Year 2 Monitoring Report Final

Hudson Property

DMS Project ID #: 95361

Re: Draft Year 2 Monitoring Report for Hudson Property Stream Restoration Project (95361)
Tar-Pamlico River Basin; CU 03020105
Beaufort County, NC
Contract No. 004638

Hudson Stream Restoration Project Current Condition Plan View

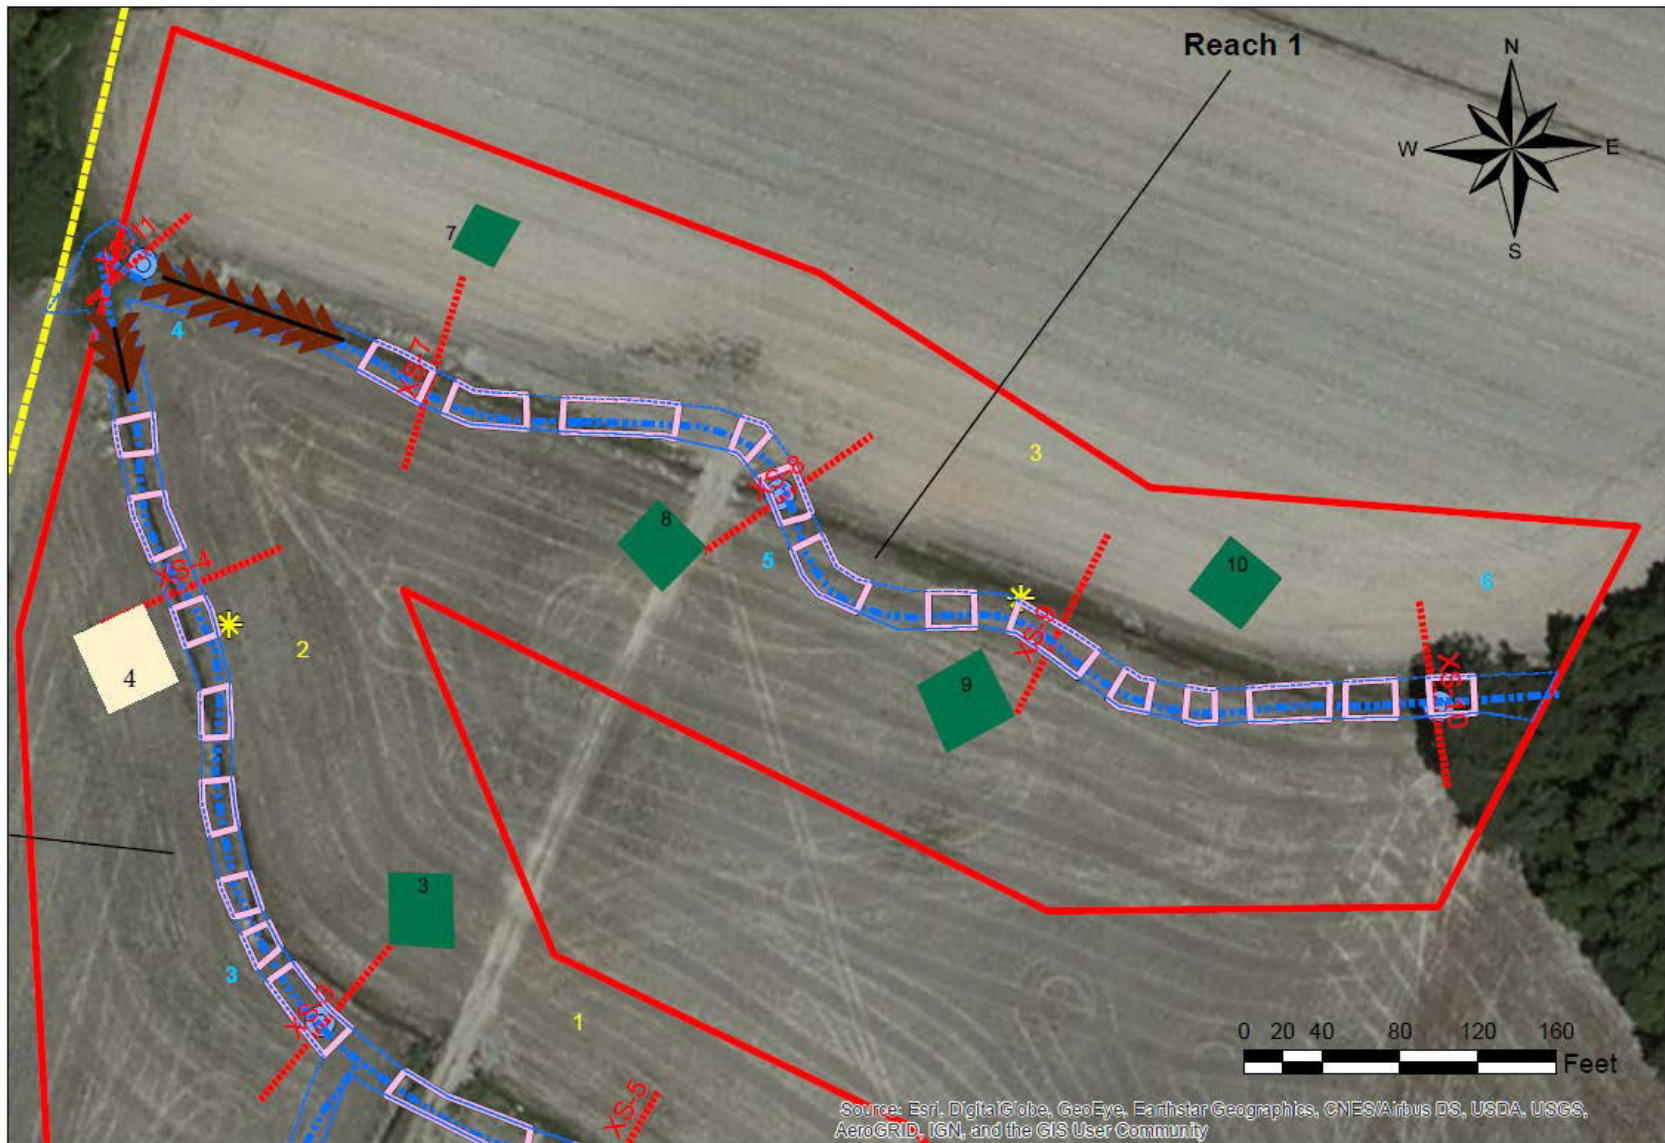
3. Appendix B, CCPV: On the Reach 1 sheet, vegetation plot 4 shows as meeting success while the data says otherwise. Please correct.

Vegetation plot 4 in Appendix B, CCPV Reach 1 sheet has been corrected.
